SUBJECT: Forwards revised detailed const plan, reflecting listed changes to 790628 submittal, per NRC 771205 request for addl info re revetment-ditch. Const scheduled to begin during Spring 1983. Approval of const plan requested by 821101.

RESPONSES TO NRC REQUESTS
FOR ADDITIONAL INFORMATION
REGARDING THE REVETMENT-DITCH
DATED DECEMBER 5, 1977
REVISED AUGUST 1982

NINE MILE POINT UNIT 2
NIAGARA MOHAWK POWER CORPORATION

NINE MILE POINT NUCLEAR STATION UNIT I
 NIAGARA MOHAWK POWER CORPORATION
 PLOT PLAN REVETMENT-DITCH

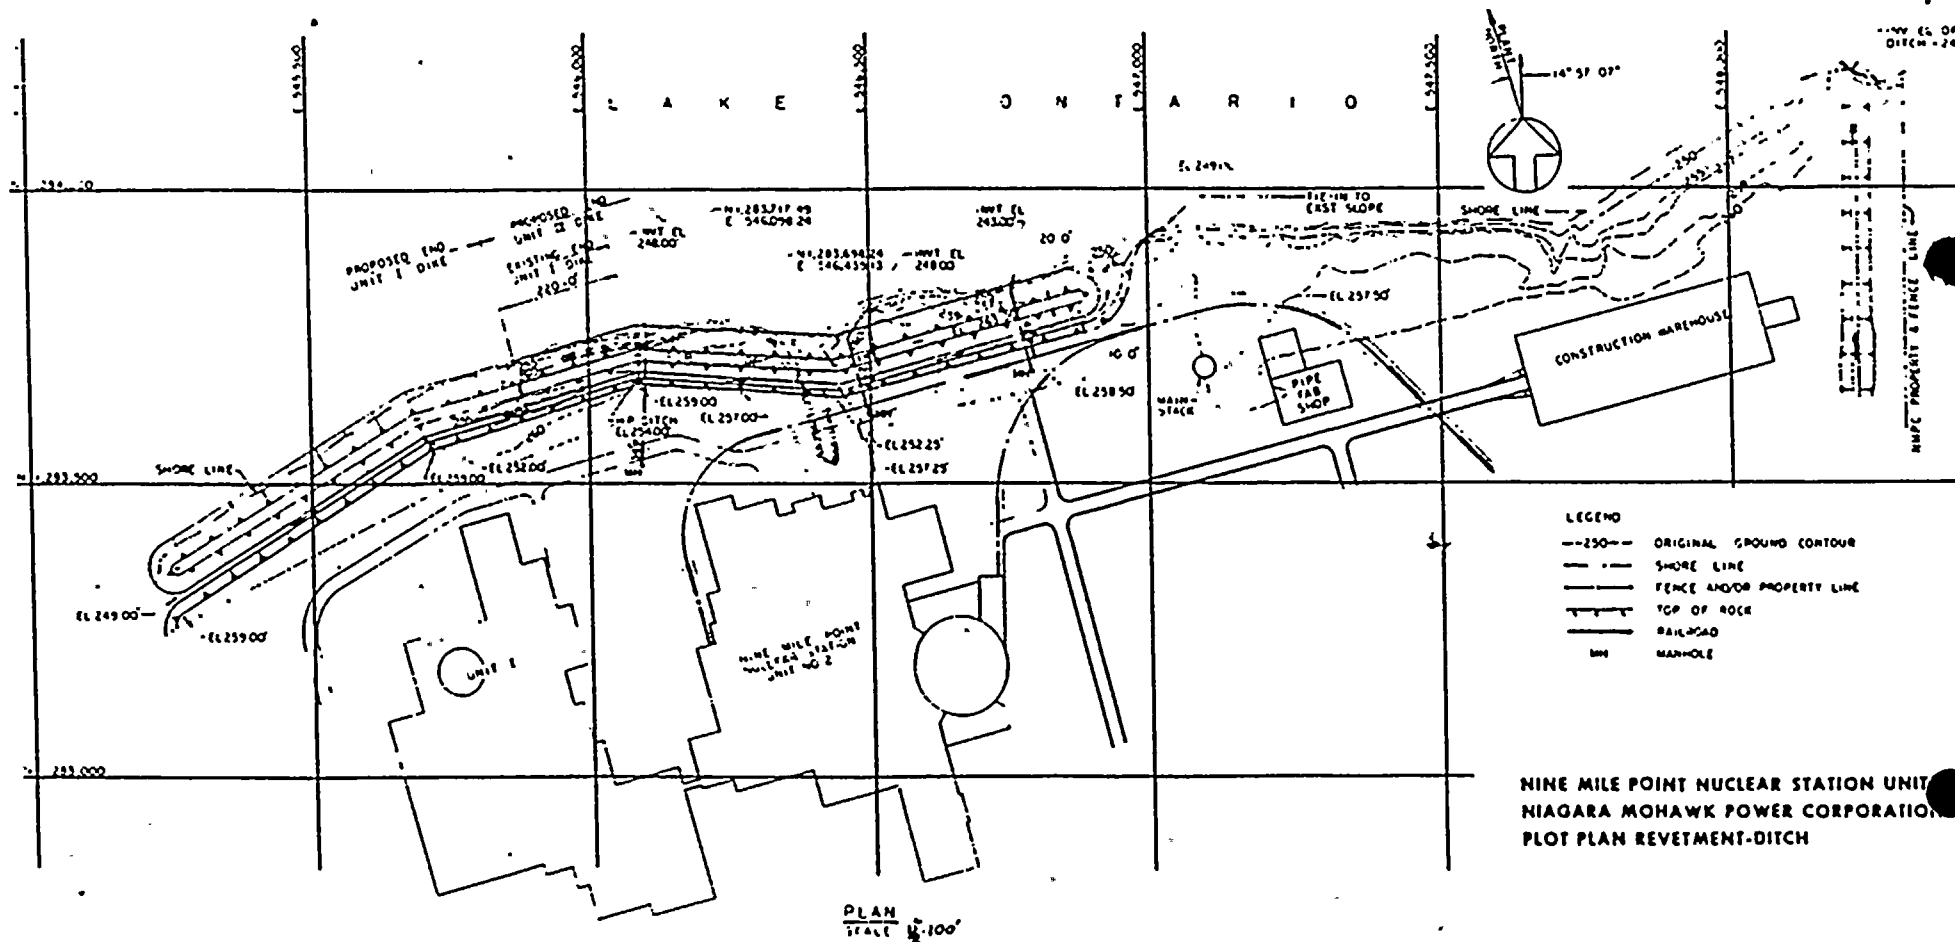
The plan view showing the overall length and alignment of the revetment-ditch with respect to the lake and the principal structures of NMP-2 and adjacent units as appropriate.

Enclosed is a drawing entitled, Plot Plan Revetment Ditch, which shows the overall length and alignment of the revetment-ditch with respect to the lake and the principal structures of Nine Mile Point Unit 2 and adjacent units as appropriate. The revetment-ditch is approximately 1300 feet in length extending from coordinates (based on New York State 500' Coordinate System) N 1, 283, 656; E 545, 870 on the west to N 1, 283, 824; E546, 876 on the east.
